# SUSITNA HYDROELECTRIC PROJECT

ACRES SPECIALIST CONSULTANTS PANEL

REPORT ON SPECIALIST CONSULTANT  
PANEL MEETING NO. 4  
NOVEMBER 18, 1981

SPECIALISTS CONSULTANTS PANEL MEETING NO. 4  
BUFFALO, NEW YORK - NOVEMBER 18, 1981

MAIN DAM SECTION AT MAXIMUM HEIGHT

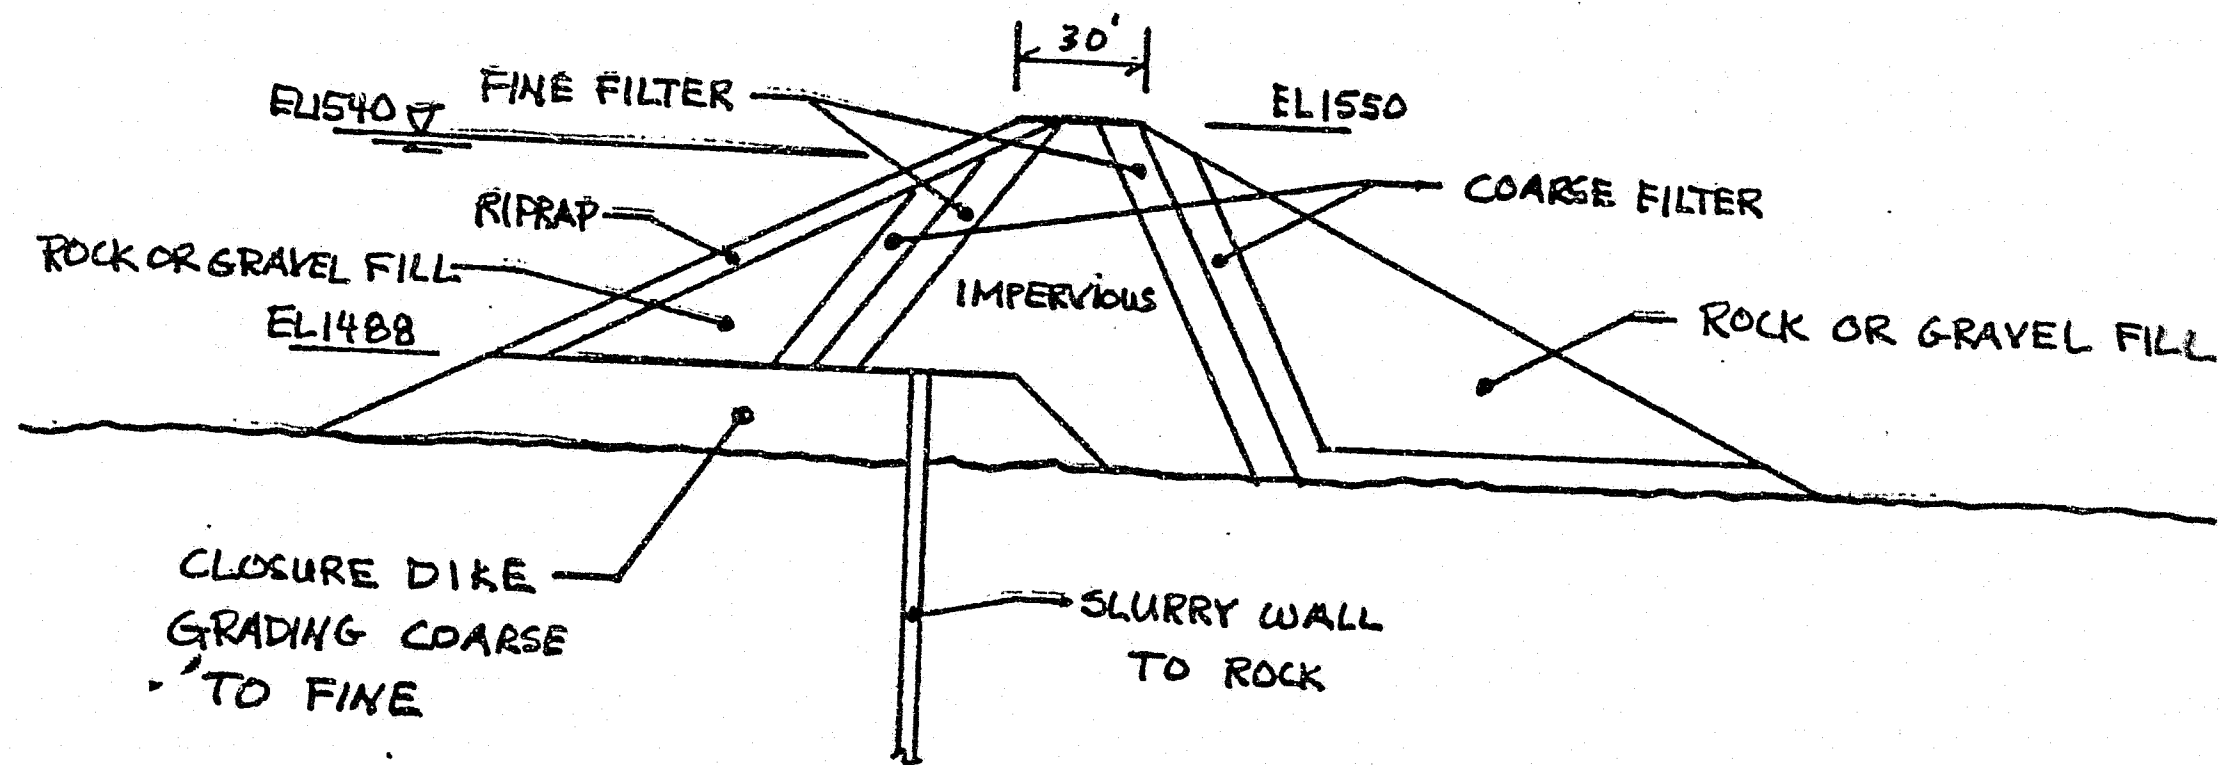
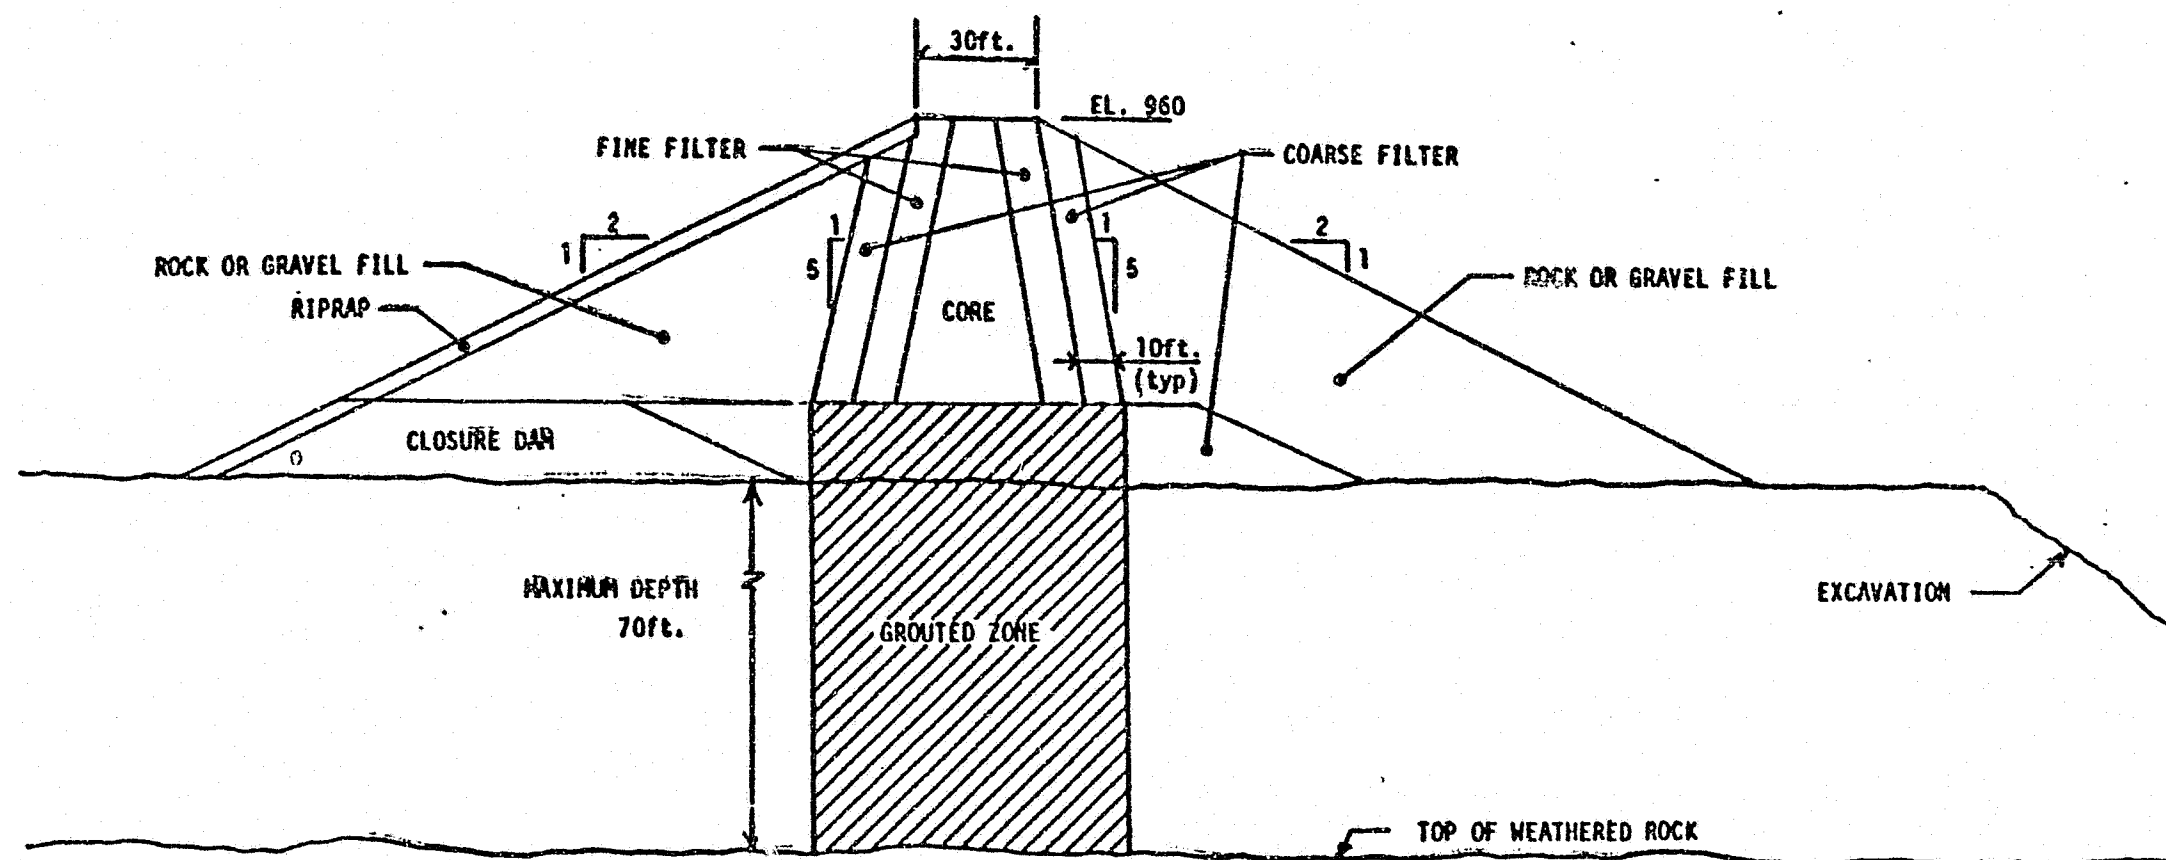
The latest dam cross section was presented showing the free draining rock fill upstream shell and river gravel downstream shell.

Dr. Peck was concerned about the use of compacted rock fill for the upstream shell. He would expect such material to settle 3 feet to 4 feet on saturation during filling and this could give rise to a longitudinal crack in the crest of the dam.

Acres explained that the present cross section was based on suggestions from the last panel meeting when Dr. Seed was concerned about the drainage characteristics of the gravel. The pore water pressure buildup under seismic loading was a major design factor and clean processed rock fill was chosen for the upstream shell for this reason. The unprocessed gravel for the downstream shell was chosen mainly on a cost basis.

The geometry of the dam was outlined with 2.25:1 upstream slope and 2:1 downstream slope for purposes of analyses. However, a 2.4:1 upstream slope was being used for layout studies. There followed much discussion on the relative merits of sloping the core. Tawil pointed out that slightly inclined cores appear to be favored on a number of large dams. This arrangement is believed to give better compressive stresses in the core and less potential for cracking.

Theoretical analysis shows that for a symmetrical core, tensile stresses are produced on the downstream edge. An inclination upstream will prevent this. Tawil quoted Mica and LG2 as examples of this.

Dr. Peck did not agree that inclined cores were selected for these reasons and explained that the location of the core at Mica was for reasons other than stress distribution in the core. The location of the core of Infernillo dam was also discussed.

Dr. Hendron said that during shaking by an earthquake the shells will tend to settle more than the core. With a central core, the shells will not tend to settle away from the core which could lead to cracking of the core.

In conclusion it was generally agreed that symmetrical core is the most suitable arrangement for Watana dam.
